Revision B1 Errata

The errata listed below describe situations where DS26514 revision B1 components perform differently than expected or differently than described in the data sheet. Maxim Integrated Products, Inc., intends to correct these errata when the opportunity to redesign the product presents itself.

1) TTIP/TRING OUTPUTS NOT HIGH IMPEDANCE WITH TXENABLE LOW DURING POWER-UP

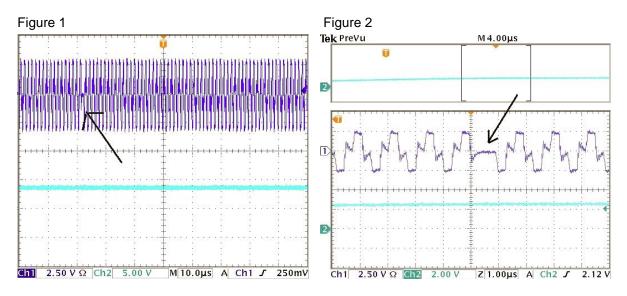
The TTIPn/TRINGn line drivers should be high impedance whenever TXENABLE is low. On rev B1 devices the TTIPn/TRINGn line drivers are briefly enabled during power-up, even if TXENABLE is low. This may cause the inactive DS26514 in a Y-cable application to attenuate the transmit waveform of the active DS26514 and create a bit error, as seen in the figures below.

Workaround: None.
